From: James. D. Fitzgerald, P.E., LEED AP

Date: May 31, 2017

Subject: 455 Harvard Street, Brookline (40B)
Traffic Peer Review

Figure 2: Proposed Parking Plan

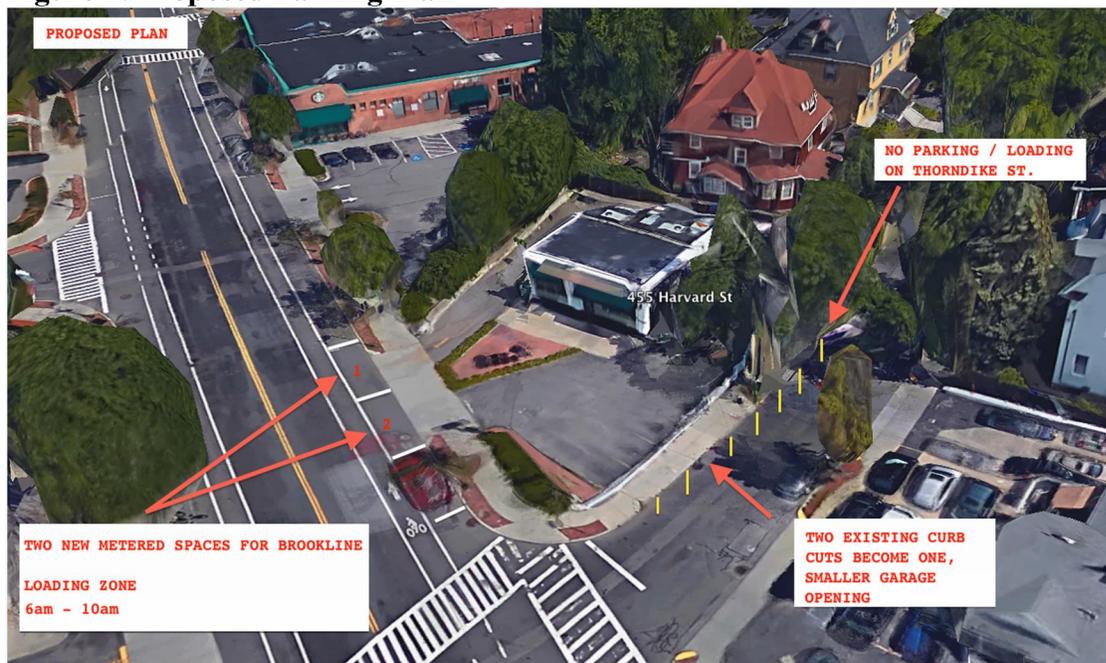
The site driveway is proposed at 19 feet wide but zoning requires a 20 feet width for two-way access.

In order for a passenger vehicle to turn right out of the proposed driveway and remain on their side of the road, the driveway apron needs to be widened.

The plan shows a driveway transition being retained at this location despite it no longer providing driveway access and a building being located along the back of sidewalk. It is recommended that a conventional sidewalk with 6-inch curb reveal be installed for pedestrian protection. Given the sight distance concerns from the Thorndike Street approach (discussed above), consideration should be made when laying out the loading zone, curb location, and adjacent parking (and potential curb extension) in order to provide adequate visibility from the Thorndike Street approach.

- The Loading Zone Narrative indicates loading hours from 5 am to 9 am, while the Proposed Parking Circulation Plan shows hours from 6 am to 10 am. Clarification is requested.
